Access Compliance Report

Intersection ID: 13859	Main Street: CLEVELAND_AV	Cross Street: RENSSELAER_AV	Location: E
ADA ID: D22454770AA4	Ramp Type: PerpDiag	Initial Pass/Fail: Fail	Overall Compliance: No
Severity Score: 37.5			
Codes/Mitigation Info/Possible Solution		Field Measurements/Component Compliance

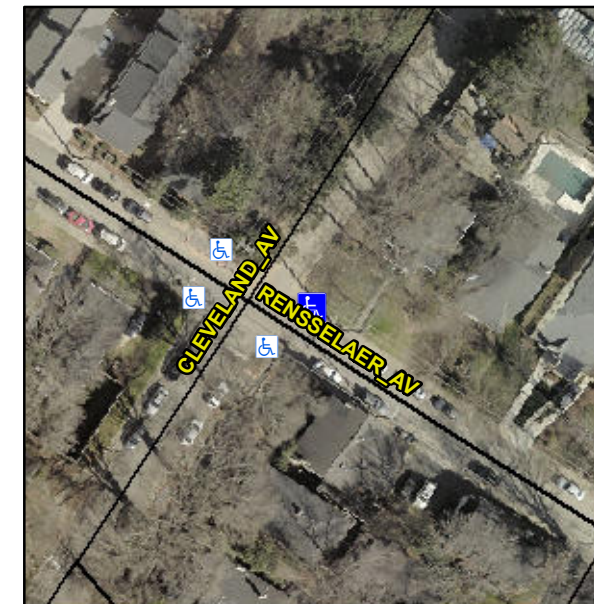
Not Found, R304.2.2, R304.5.3

Compliance	Description	Data	Compliance	Description	Data
N/A	Ramp Length (in)	24.0	No	Ramp Slope (%)	11.9
Yes	Ramp Width (in)	60.0	No	Ramp XSlope (%)	12.0
N/A	Flare Type LT	N/A	N/A	Flare Type RT	N/A
N/A	Flare Slope LT (%)	N/A	N/A	Flare Slope RT (%)	N/A
N/A	Flare Traversable LT?	N/A	N/A	Flare Traversable RT?	N/A
N/A	Landing Length (in)	N/A	N/A	DWS Provided?	N/A
N/A	Landing Width (in)	N/A	N/A	DWS Contrast?	N/A
N/A	Landing Slope (%)	N/A	N/A	DWS Length (in)	N/A
N/A	Landing X Slope (%)	N/A	N/A	DWS Full Width?	N/A
N/A	Landing Curb? (Y/N)	N/A	N/A	DWS Offset (in)	N/A
N/A	Shared Landing?	N/A			
N/A	Gutter Ponding?	N/A	N/A	Gutter Slope (%)	N/A
N/A	Gutter Lip Ht (in)	N/A	N/A	Gutter X Slope (%)	N/A
N/A	Painted X Walk1?	No	N/A	Painted X Walk2?	No
	X Walk 1 Direction	To NW		X Walk 2 Direction	To SW
N/A	X Walk 1 Width (in)	N/A	N/A	X Walk 2 Width (in)	N/A
	X Walk 1 Slope (%)	2.7		X Walk 2 Slope (%)	2.6
	X Walk 1 X Slope (%)	5.0		X Walk 2 X Slope (%)	2.1

Remove & Replace Curb Ramp With Two New Directional Ramps or Equivalent.
